MARCH 9 1978

AMENDMENT TO FACILITY OPERATING LICENSE

Amendment No. 29
License No. DPR-35

ATTACHMENT TO LICENSE AMENDMENT NO. 29

FIGURE 6.2.3

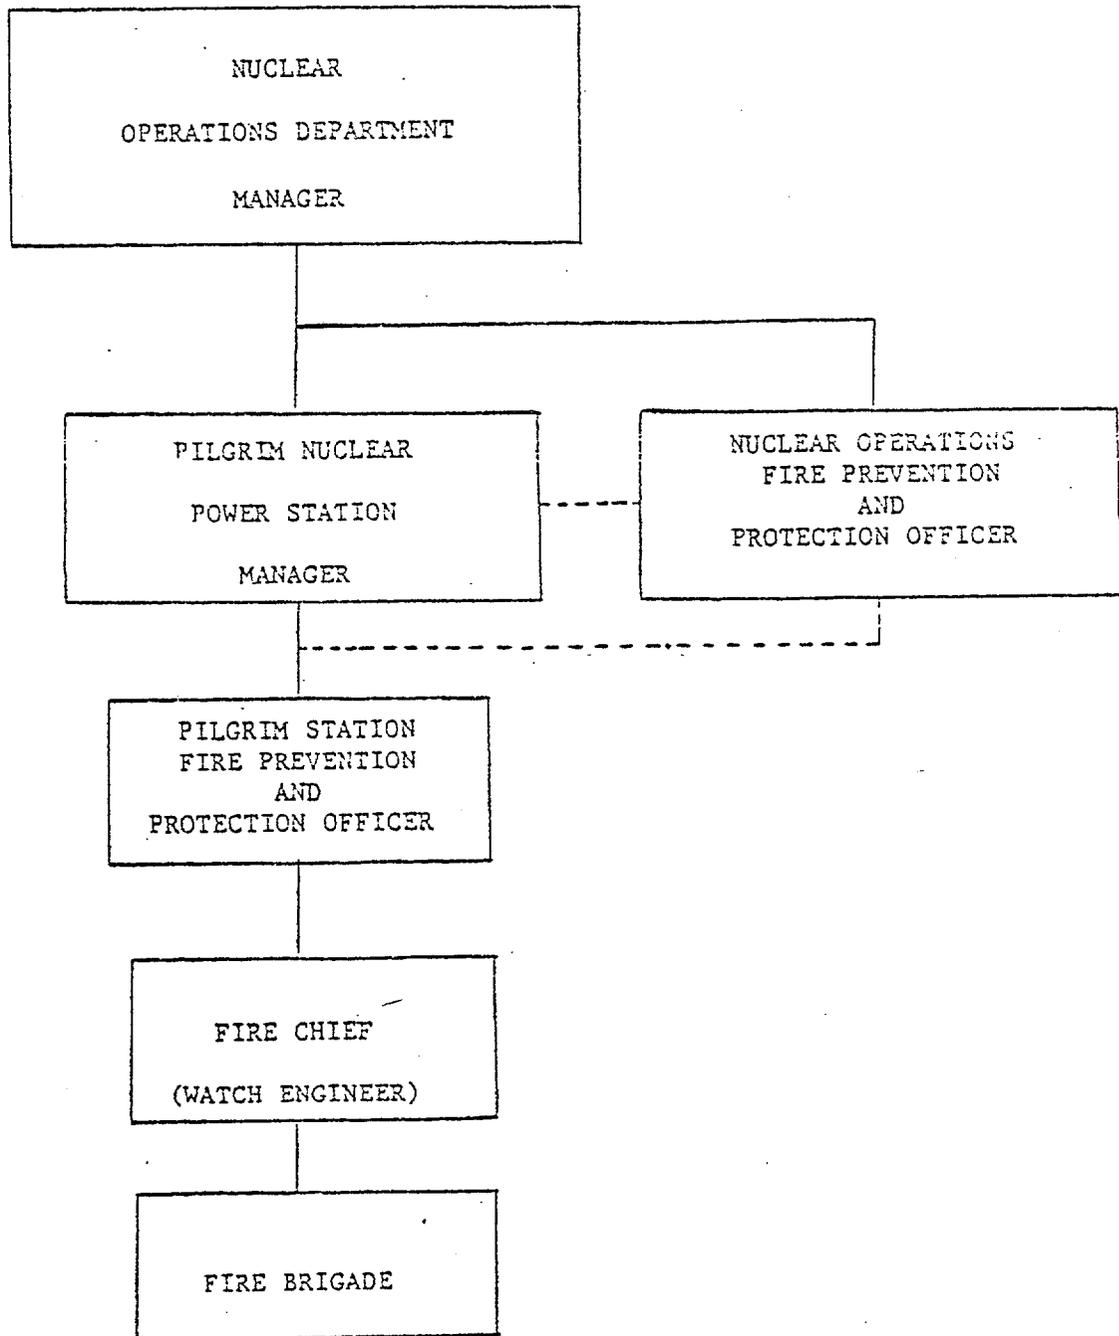
6. The organization of the administration of the Pilgrim I Fire Prevention and Protection Program shall be as shown on Figure 6.2.3. A Fire Brigade of 5 members including the Fire Chief shall be maintained on site at all times. This excludes 3 members of the minimum shift crew necessary for safe shutdown and any personnel required for other essential functions during a fire emergency.
